James Mason, CM, A.C.E.
Bay City Regional Airport
3598 FM 2540 North
Bay City, Texas 77414

Permit Application Technical Review: Permit Application: Structure PC2183 – Wind Turbine

We have completed a review of the structure reference above. This structure was previously studied under FAA's airspace review as study 2022-WTW-3558-OE. This review is organized around the following sections of the ordinance:

PLAN: TURBINES PC2-183 & PC2-239

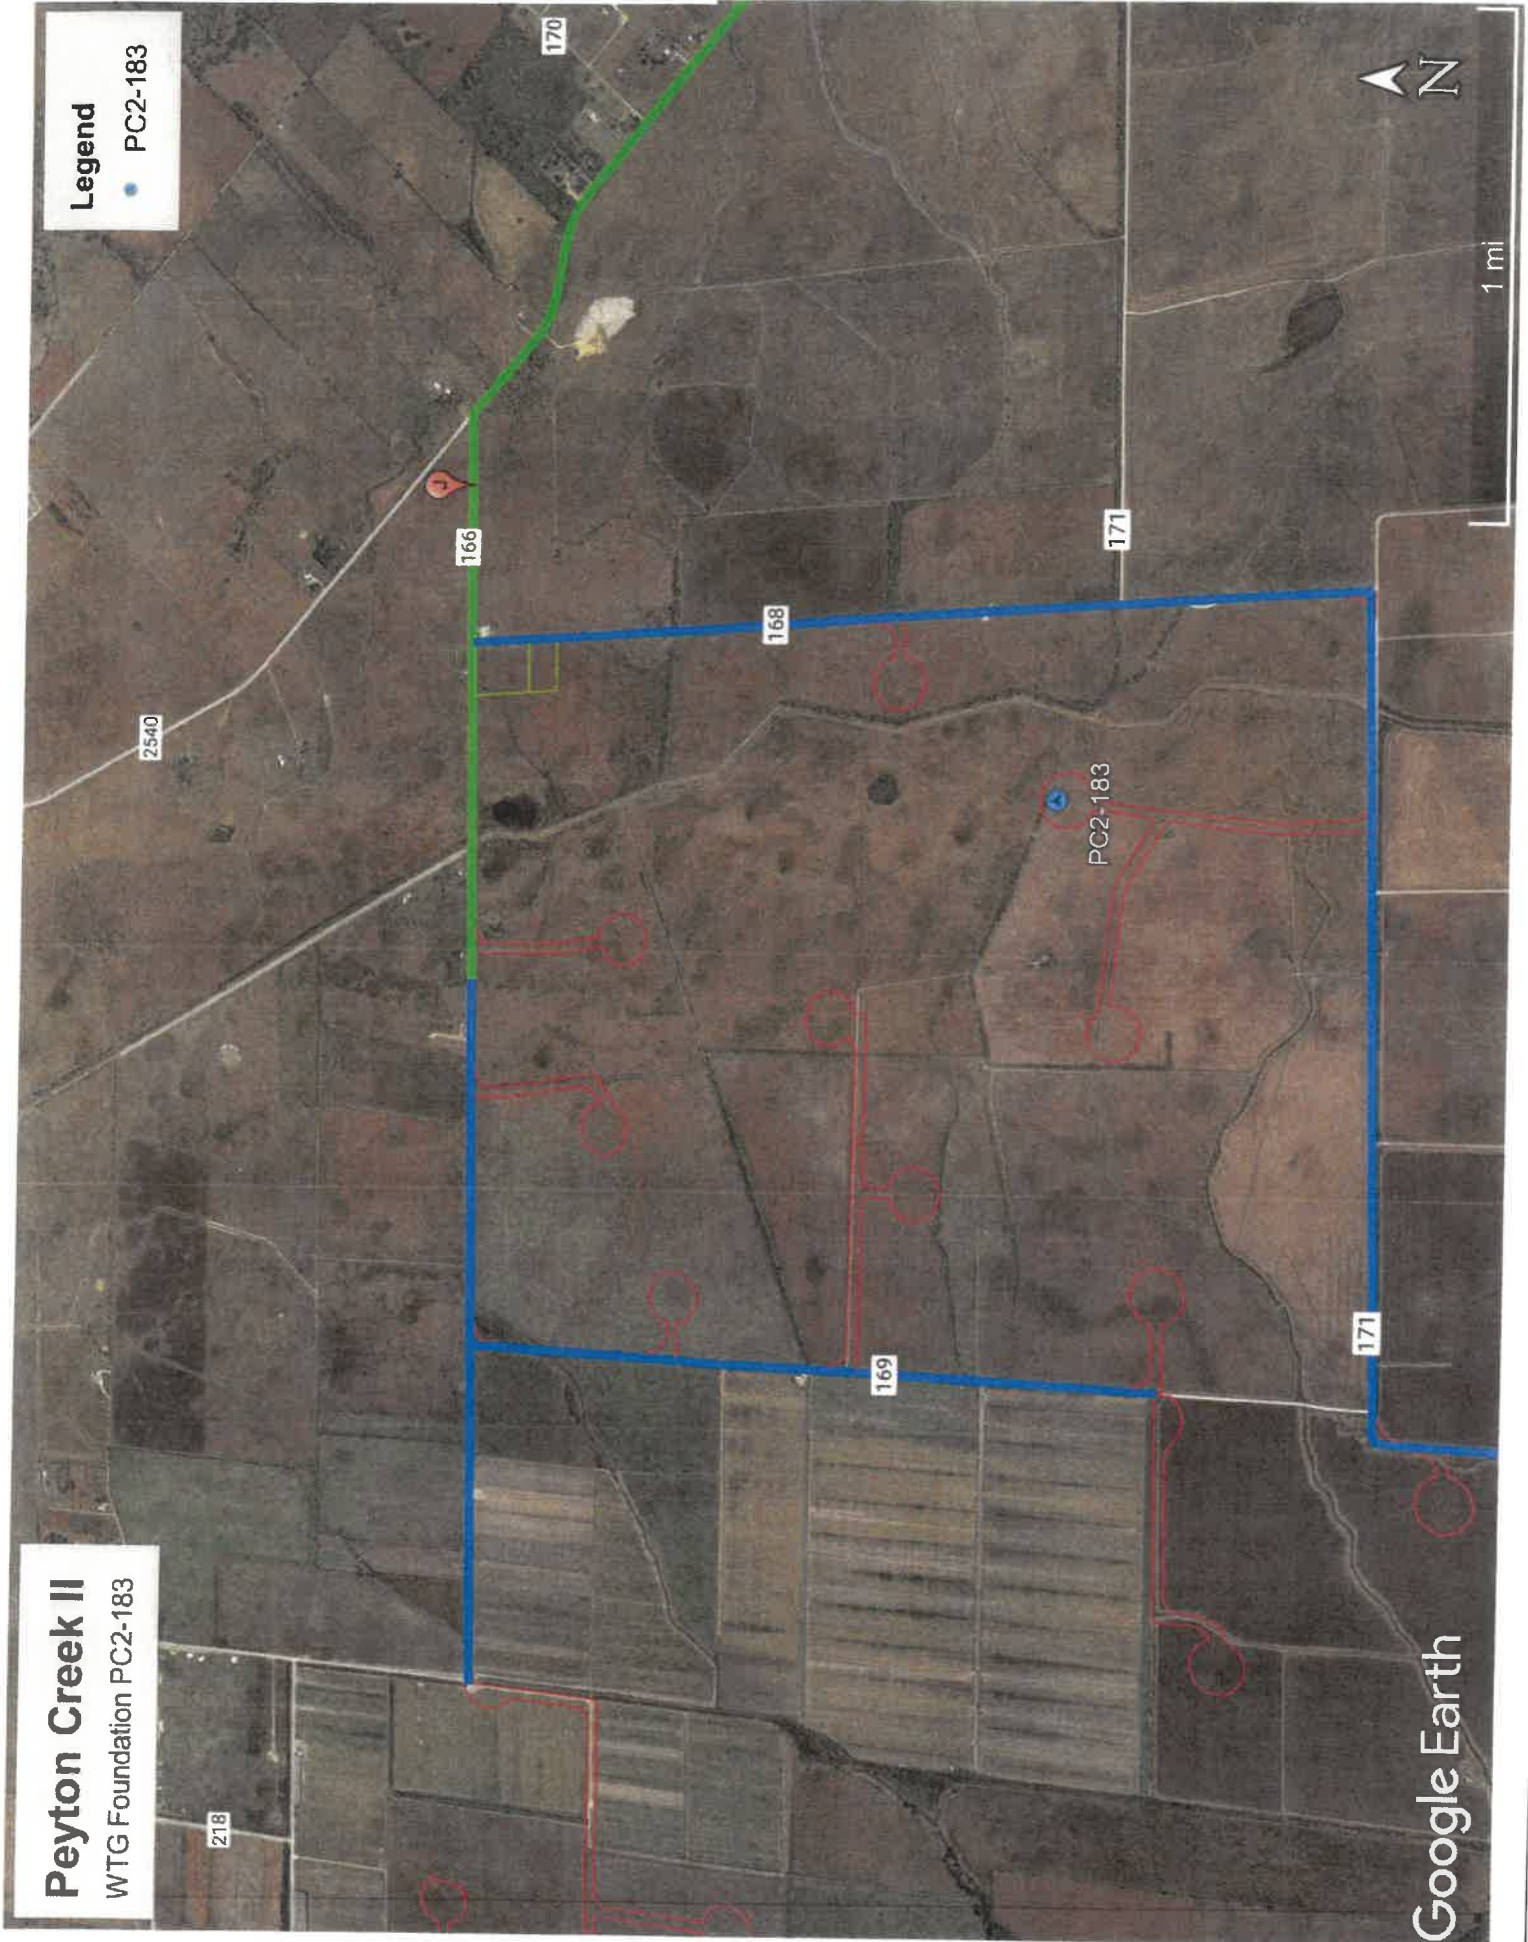
Reasons: This section does not permit use of land or water in the entirety of Matagorda County that might impair visibility in the vicinity of the airport, or otherwise in any way endanger or interfere with the landing, taking off, or maneuvering of aircraft intending to use the airport. This proposed item will affect taking off from the airport:

1. This proposed structure is located 3.72 nm from the end of Runway 31. This structure is within the "Diverse Departure Assessment Area" as defined under FAA Order 8260.3D and may require an Obstacle Departure Procedure. For southbound departures from the runway toward the proposed structure, the climb gradient needed to provide proper clearance over the structure will exceed the standard climb gradient; this has been noted in the airspace determination letter of March 15, 2023. Such a requirement interferes with operating out of the airport compared to the operating requirements today.

Based on the information provided above, we find this proposed structure to be contradictory to the zoning ordinance and hereby do not recommend approval of this structure.
